Certificate of Appropriateness for  
2122 Regent St

September 16, 2019

# Proposed Work

FRONT ELEVATION

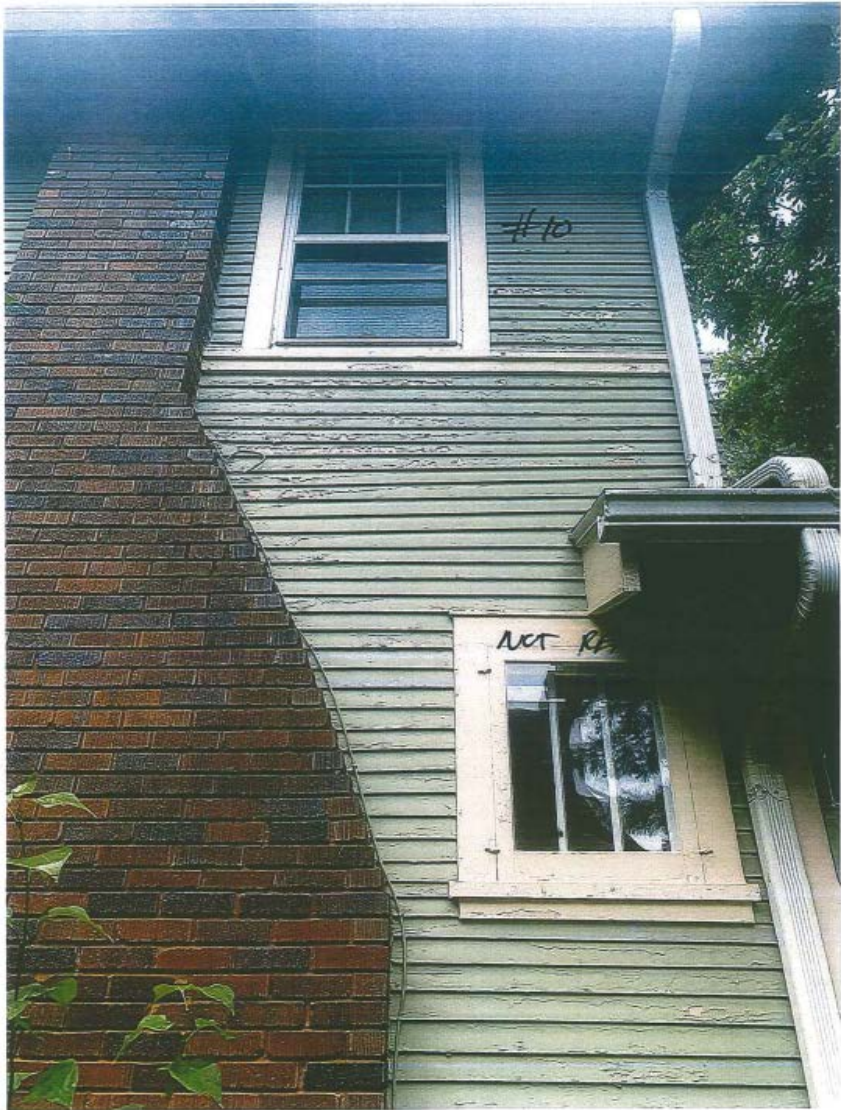
\* NOT DOING R  
~~Porcht activities #1~~

\*All windows on whole  
house will have a whole  
exterior

LEFT ELEVATION

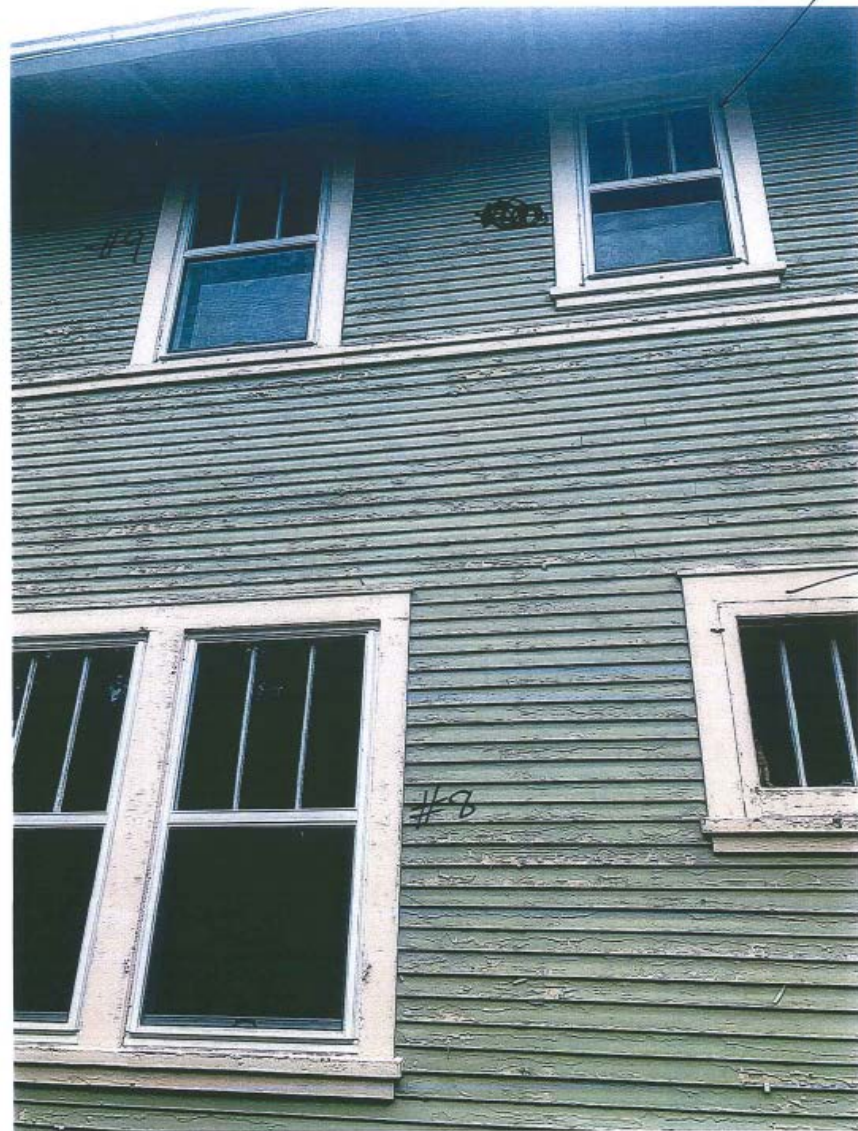
Not  
Replacing

BACK ELEVATION

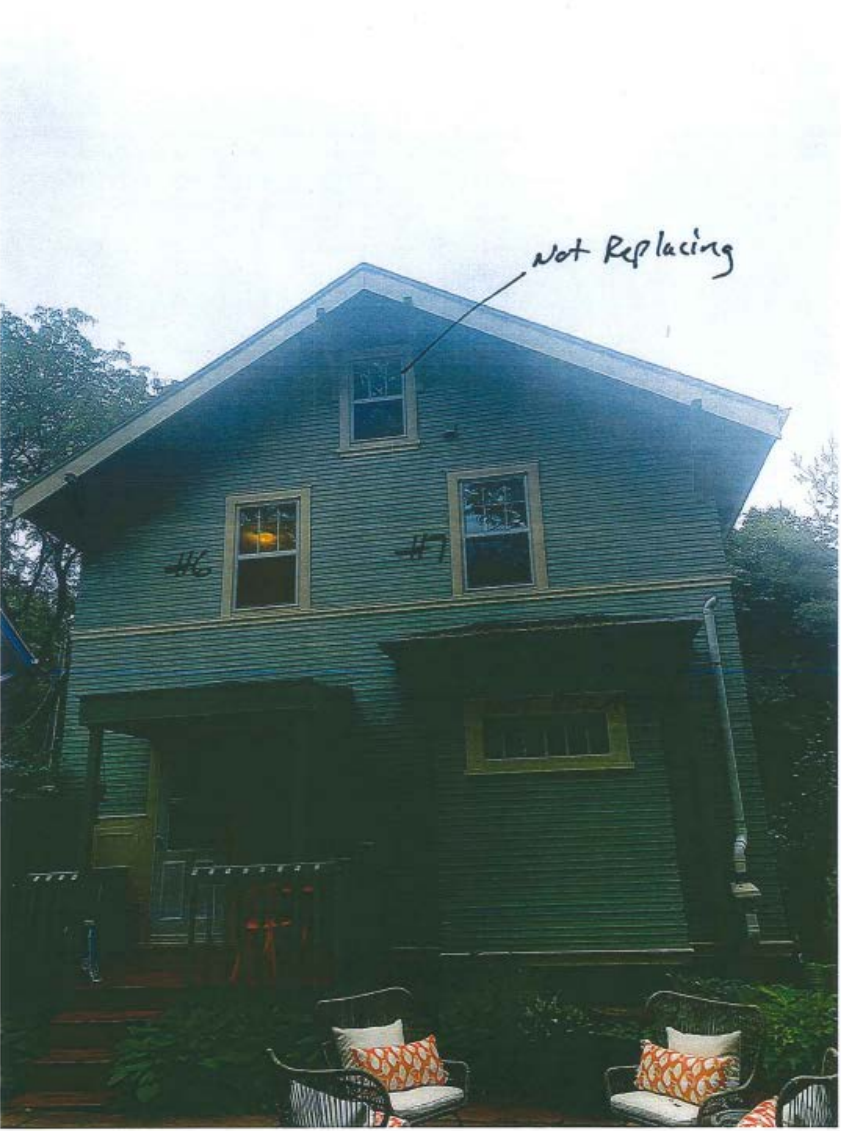
Not Replacing
